ITEM 26

FINAL PLAT REVIEW FOR STONE RIDGE LLE SUBDIVISION, CONTAINING 5 LOTS ON 69.98 ACRES LOCATED OFF HARPETH SCHOOL ROAD IN THE 2ND VOTING DISTRICT (1-2025-411).

FINAL PLAT REVIEW FOR STEPHENS VALLEY SUBDIVISION, SECTION 12, CONTAINING ZERO (0) LOTS ON 0.77 ACRES LOCATED OFF STEPHENS VALLEY BOULEVARD IN THE 8TH VOTING DISTRICT (1-2025-429).

CONCEPT PLAN REVIEW (REVISED) FOR KINGS CHAPEL SUBDIVISION, CONTAINING 449 LOTS ON 615.28 ACRES LOCATED OFF MULLENS ROAD IN THE 5TH VOTING DISTRICT (1-2025-209).

ATTACHMENT 29-1A

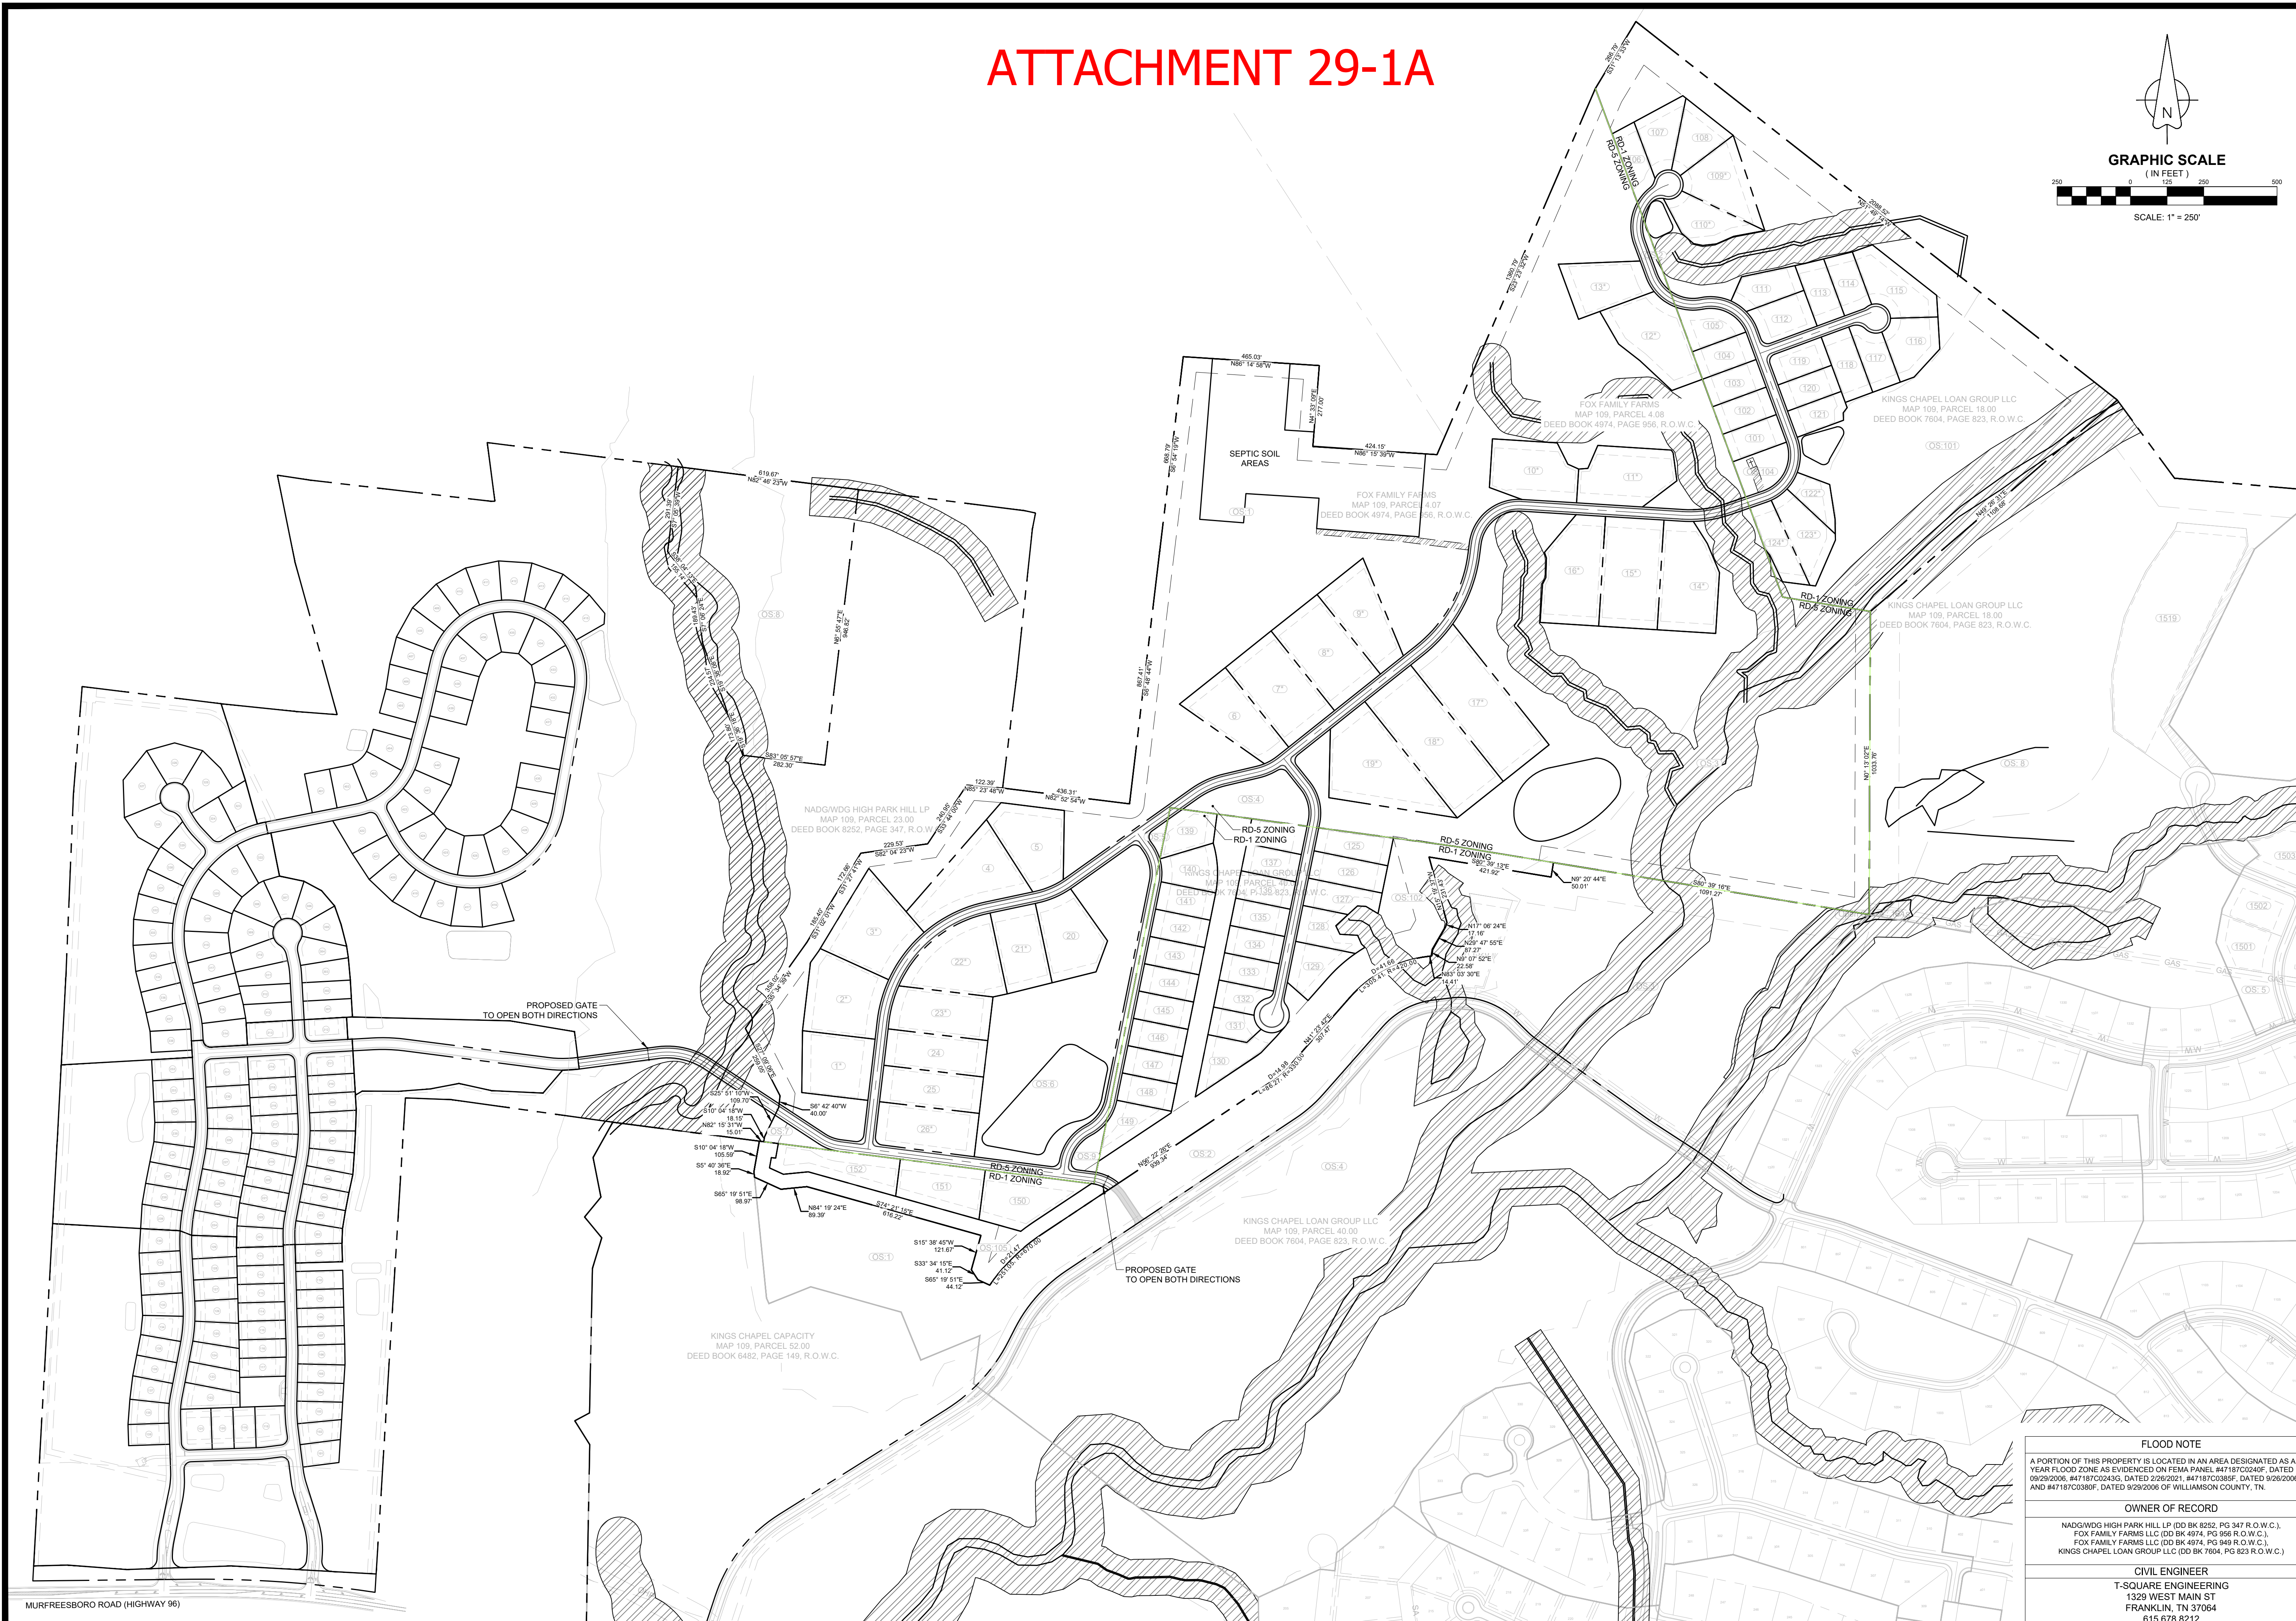
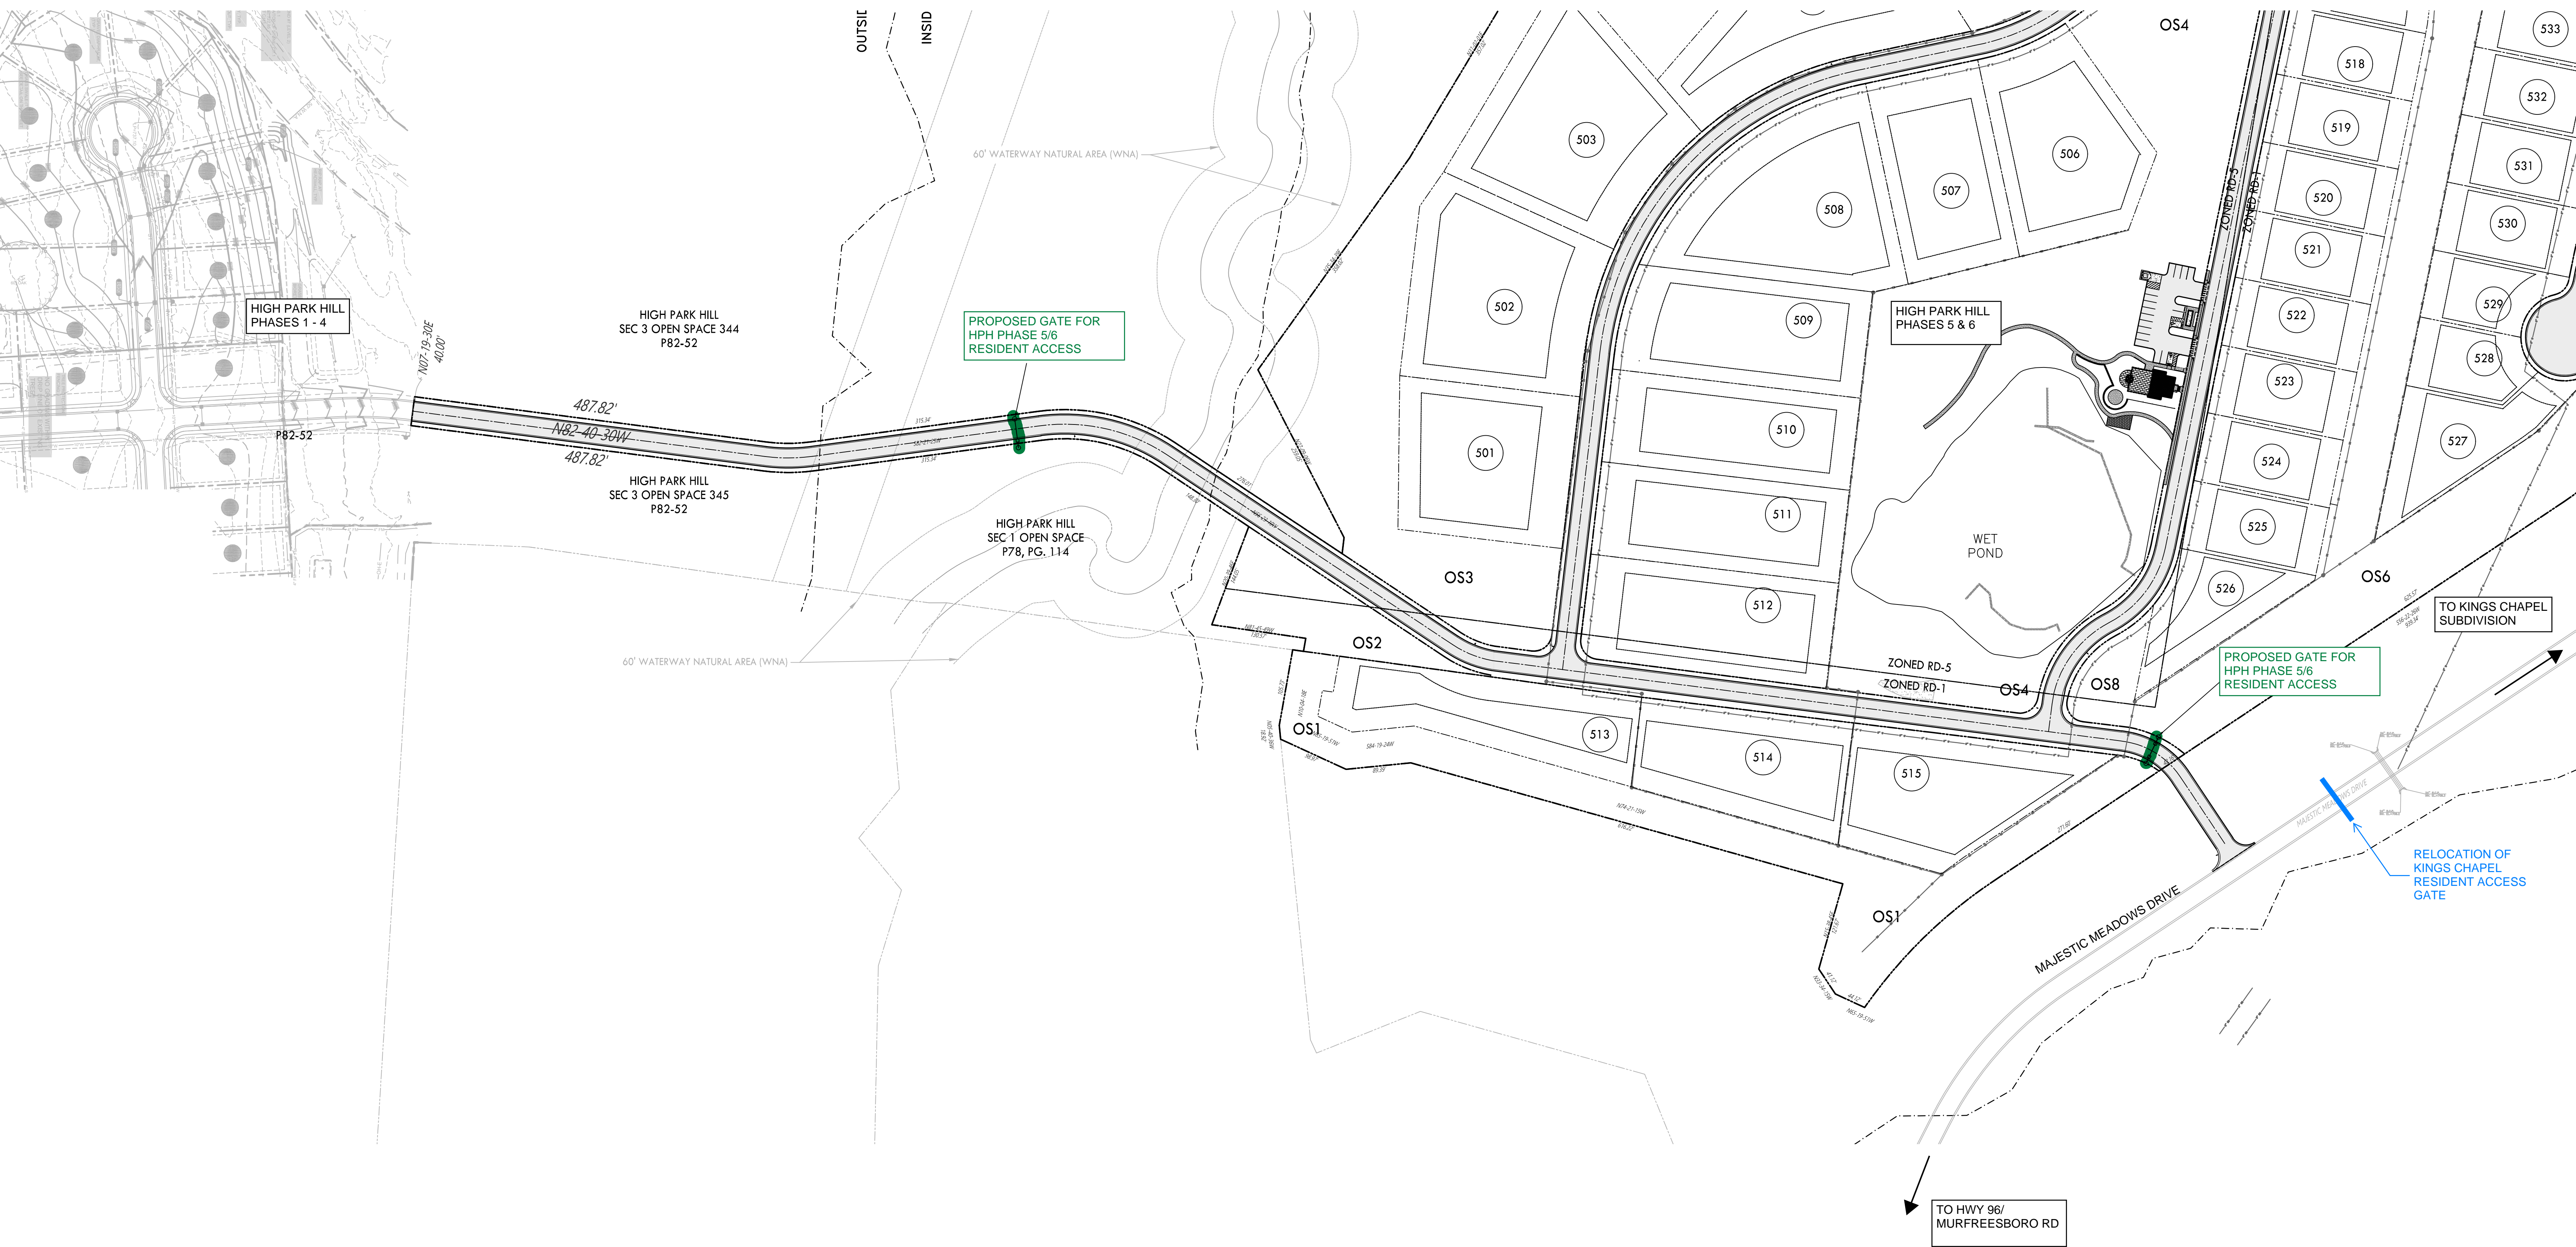
A Revised Concept Plan for this development was approved at the September, 2023 meeting, which included an additional 195 acres and an additional seventy-eight (78) lots. The additional acreage and lots were intended to be added to King's Chapel, the adjoining development. However, Staff had determined the King's Chapel Concept Plan could not be amended, and the developer proposed to add the additional acreage and lots to High Park Hill. At that time, Staff recommended, and it was added as a condition of approval, that there be a single gated connection between the developments, which would be located in the High Park Hill development and restricted to emergency vehicles and utility service providers. This restricted connection would serve to delineate the developments as two separate and distinct developments (See Attachment 29-3). This emergency entry gate was located on Floryn Drive, north of the existing King's Chapel entry gate.

In June 2024, the applicant requested and was granted approval of another Revised Concept Plan in order to remove the entry gates at the main entrances to the development and to place a gate on Floryn Drive between Section 3 and future Sections of the development (See Attachment 29-4). The applicant had also requested removal of the condition that there be a single gated connection between the developments and limited to emergency vehicles and utility service providers, but this request was not granted. The condition carried over to the newly approved Concept Plan.

At this time, the applicant is requesting approval of another revised Concept Plan in order to remove the condition that the single gated connection between High Park Hill and King's Chapel be restricted to emergency vehicles and utility service providers, and allow the placement of a vehicular entry gate for the exclusive use of High Park Hill residents on Floryn Drive near the boundary of King's Chapel (See Sheet 2 of Attachment 29-1). According to the applicant's Letter of Intent (See Attachment 29-5), the request is being made in order to "improve connectivity and safety for residents of the High Park Hill subdivision."

Staff is of the opinion that the placement of a vehicular entry gate for the exclusive use of the residents of High Park Hill near the boundary of King's Chapel coupled with the relocation of the existing King's Chapel entry gate to the new location north of Floryn Drive, which would be for the exclusive use of the residents of King's Chapel and prohibit entry into the development by the residents of High Park Hill, would serve to delineate that these are two separate and distinct developments.

Therefore, Staff recommends approval of the Revised Concept Plan, with the removal of the condition stipulating that the one gated connection between King's Chapel and High Park Hill be restricted to emergency vehicles and utility service providers, and the added condition that the HOA documents be revised to provide for the maintenance of Majestic Meadows Drive by High Park Hill. The revised HOA documents shall be submitted with the next Final Plat of King's Chapel and High Park Hill developments, and recorded concurrently with the recording of the Final Plat.
